FEBRUARY 2020

PL6

NON MATERIAL  
AMENDMENT  
PLANNING  
APPLICATION  
& CONDITION 4  
DISCHARGE

44 A GLOUCESTER  
AVENUE LONDON  
NW1 8JD

## 2.1 CHANGES TO CONSENTED DEMOLITION BASEMENT AND GROUND FLOOR

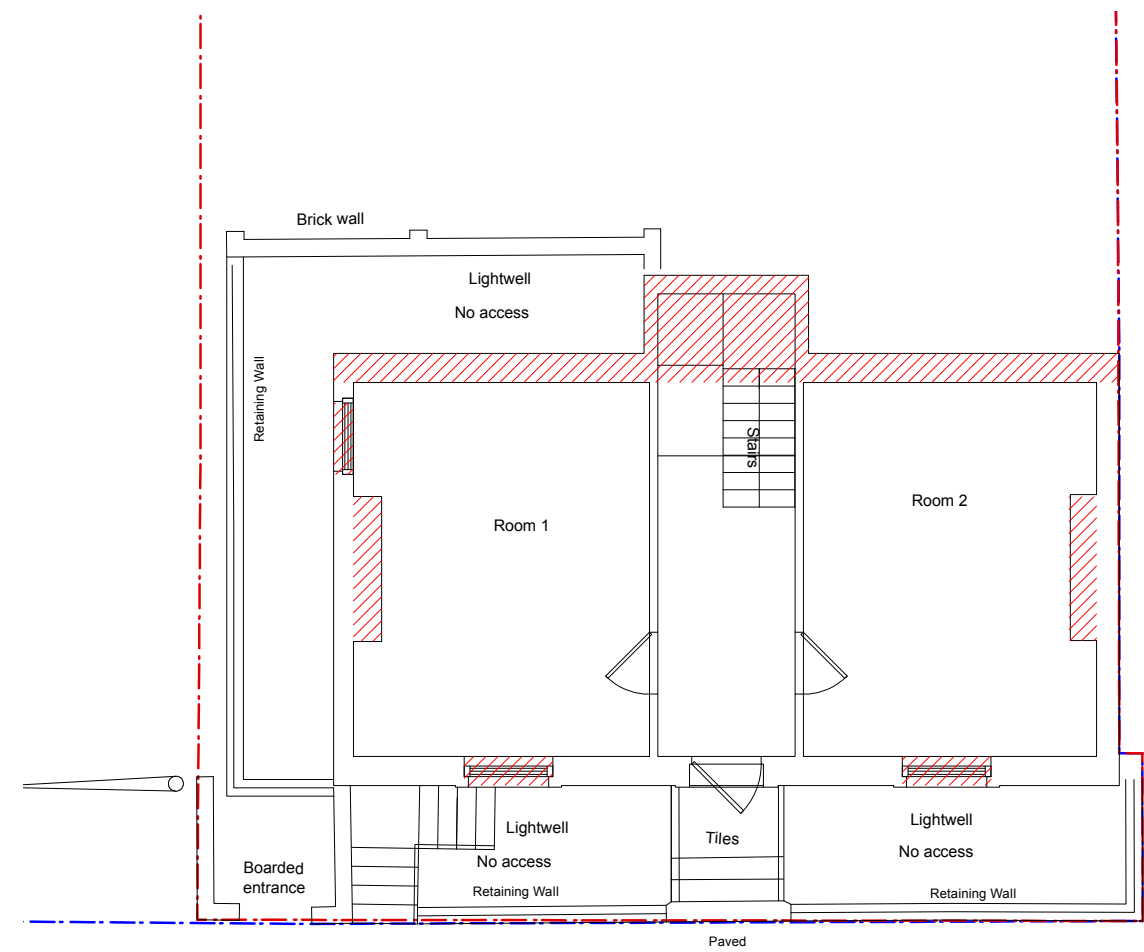
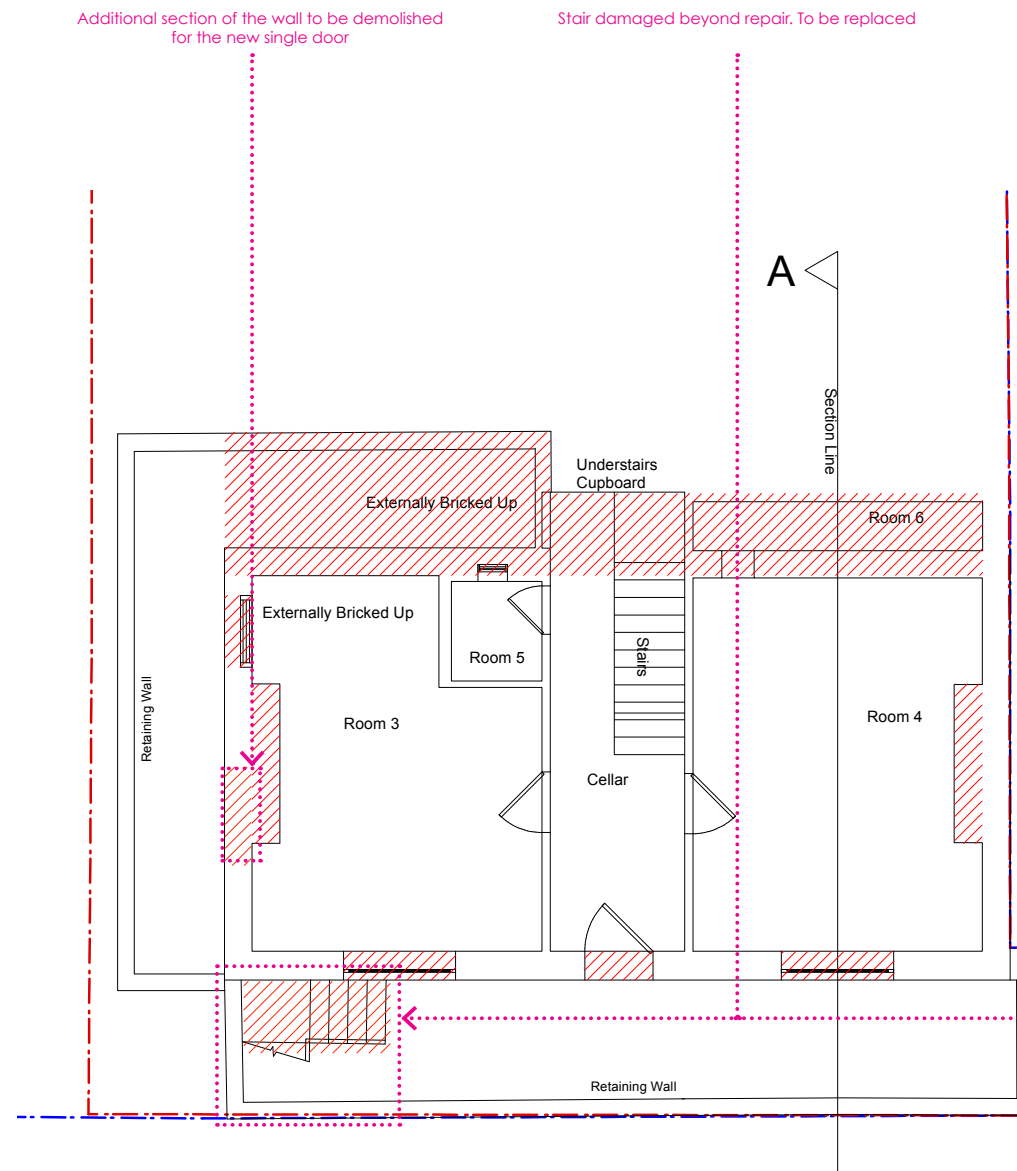
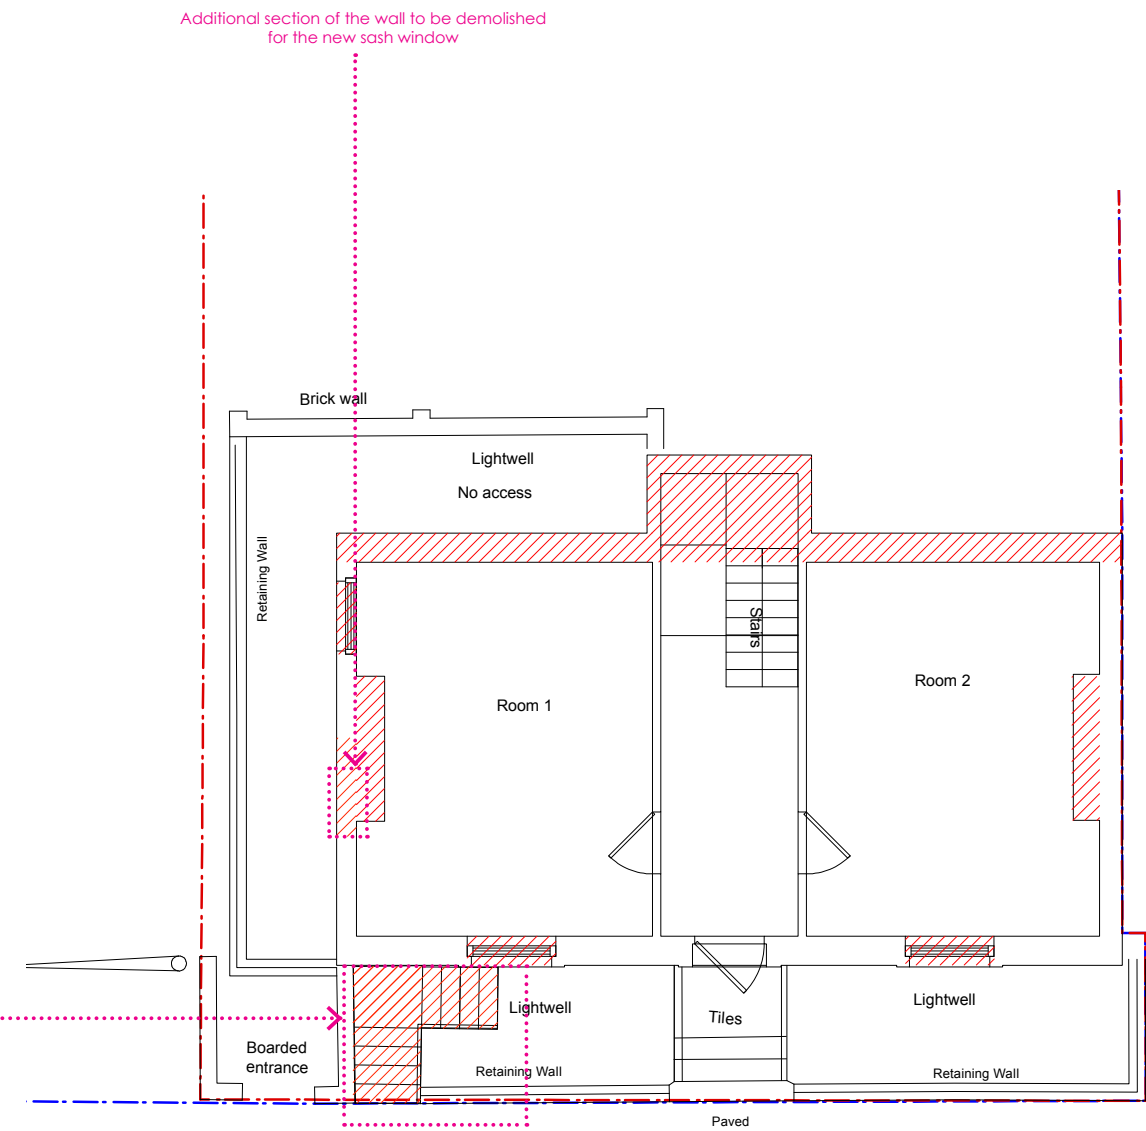
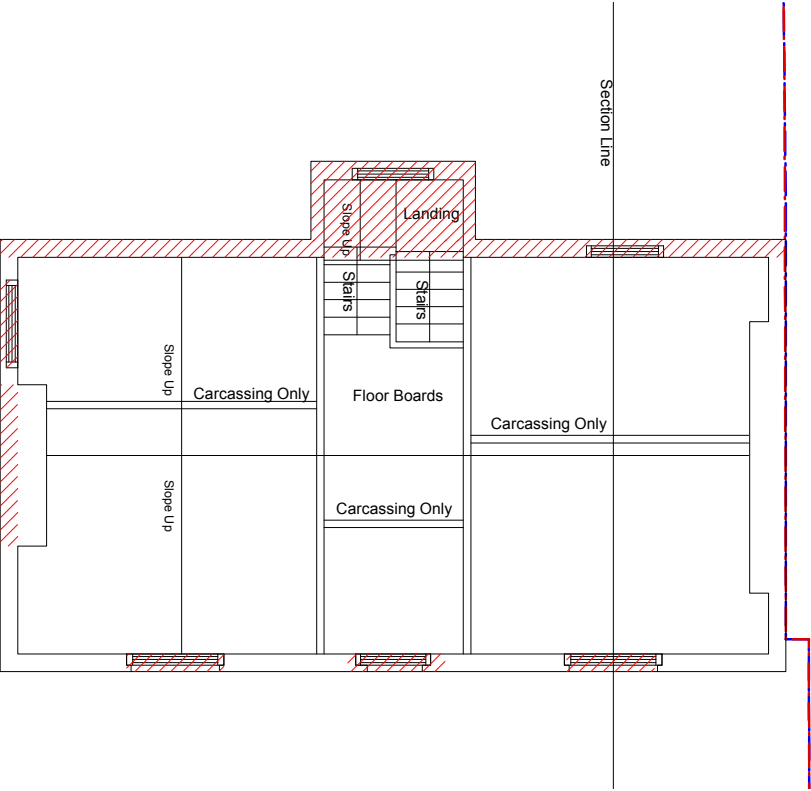
- Due to incorrect initial survey basement front balcony opening has been revised in the demolition drawings
  - Demolition drawings have been revised with correct openings in the side elevation and other minor changes

- Side basement balcony to have single door access
  - Approved store modified to cycle store, bin store relocated to rear of the courtyard and the base of the lightwell extended to the edge of the house

## 2.2 CHANGES TO CONSENT-ED DEMOLITION FIRST AND SECOND FLOORS

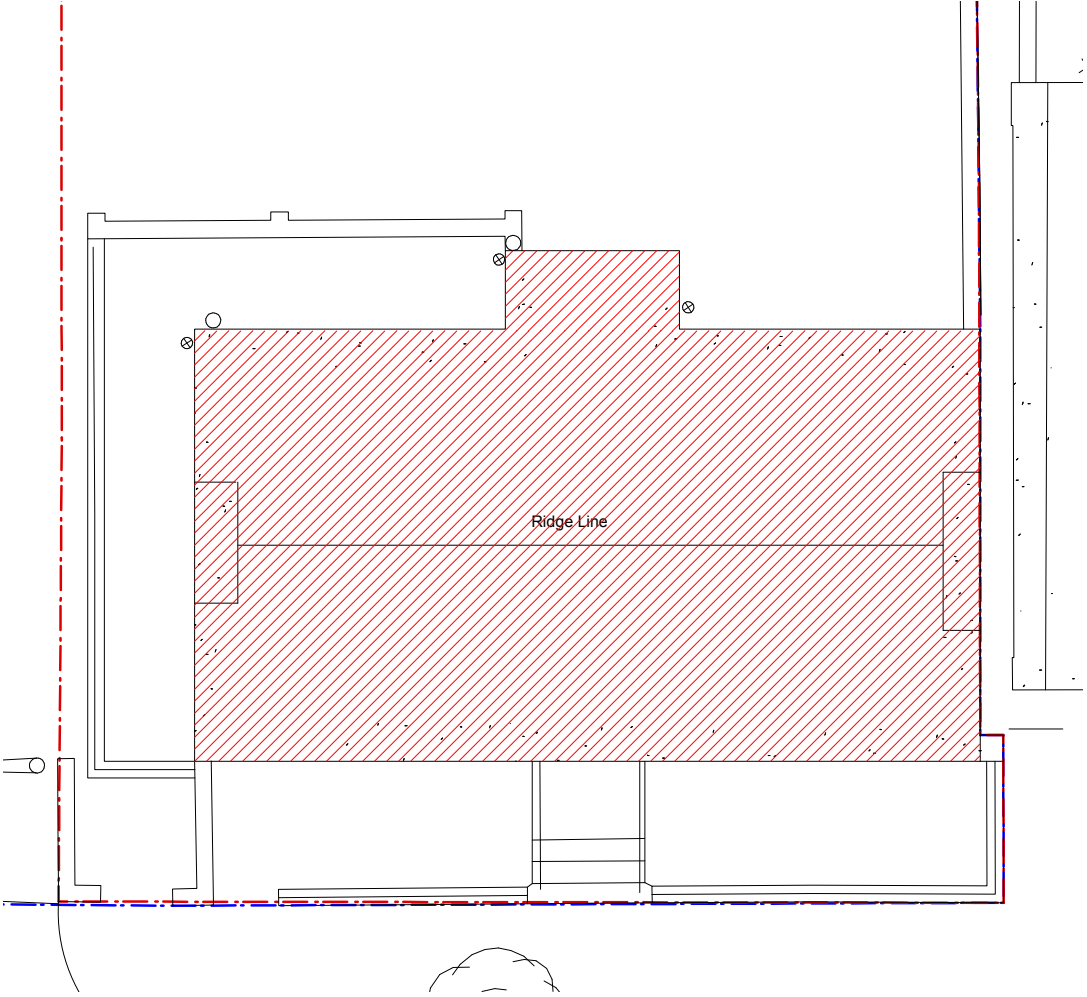
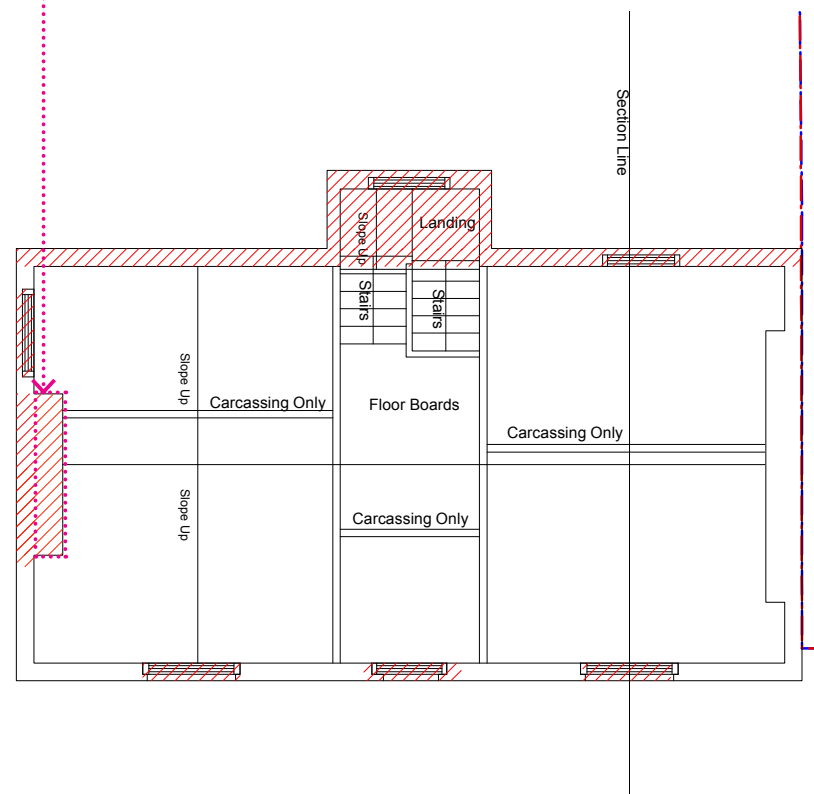
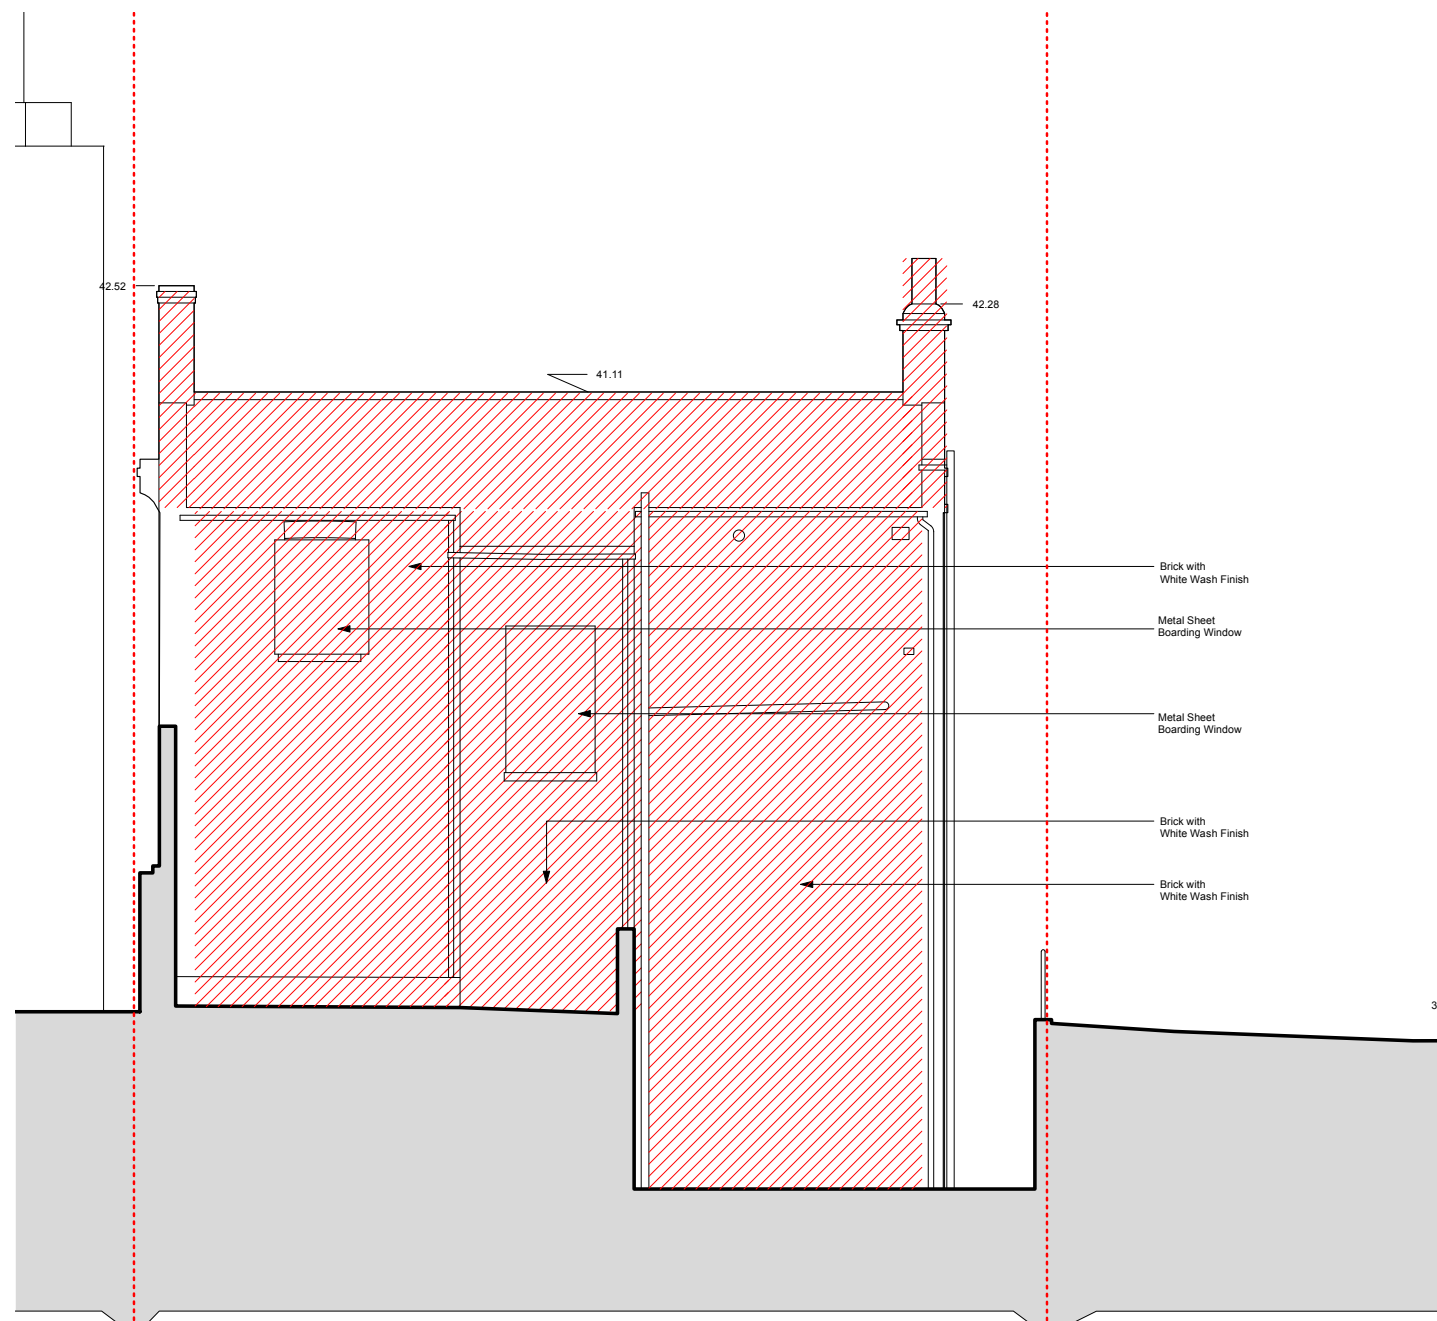
Additional opening made for the new window.  
Internal chimney breast to be demolished due  
to poor existing condition
